Sujet : Filtre électrovanne turbo, remplacement.

Subject: Wastegate command valve filter.

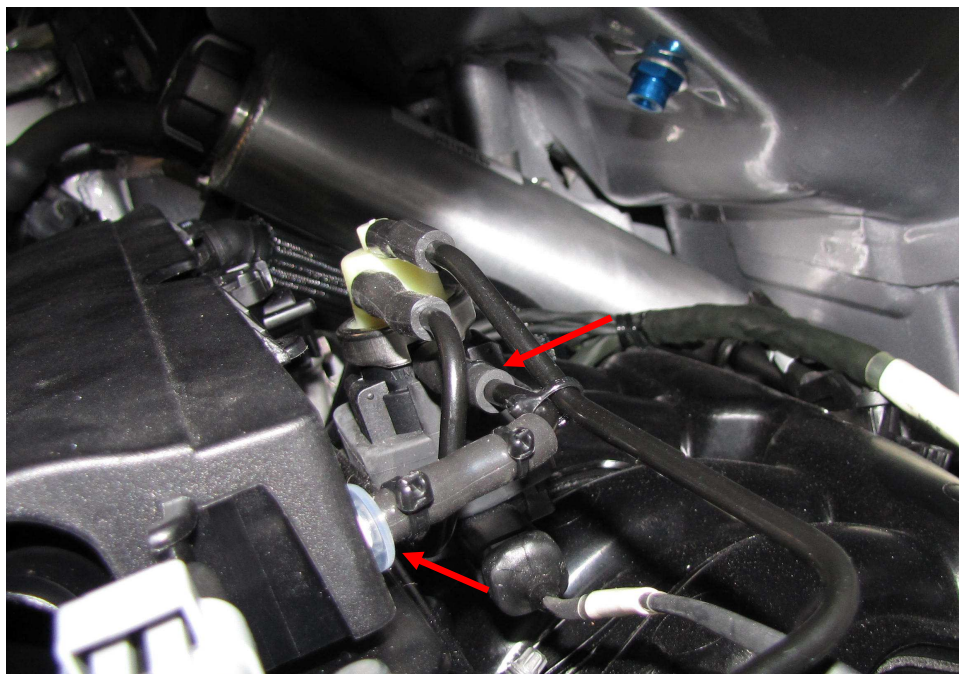
Nous attirons votre attention sur l'électrovanne de waste gate de votre DS3R3. Afin d'améliorer la filtration en amont de cette dernière, nous vous invitons à remplacer le filtre d'origine par le filtre réf PS02504A10, préalablement coupé et assemblé, en ayant pris soin de modifier la durite rigide coudée, comme illustré sur les photos ci-dessous:

We would like to draw your attention to the wastegate command valve of your DS3R3. In order to improve its filtering, we invite you to replace the original filter by the one ref. PS02504A10, modified and assembled, while having taken care to modify the bent rigid hose, as indicated on the pictures below:

Assembler le filtre sur le tube à l'aide de rilsans
Assemble the filter on the hose using tie raps

Durite souple Ø4 (type
lave-glace)
*Flexible hose Ø4 (standard
windscreen washer)*

Assembler le filtre sur l'électrovanne comme indiqué sur la photo ci-dessous :
Assemble the filter on the electrovalve as indicated on the picture below :
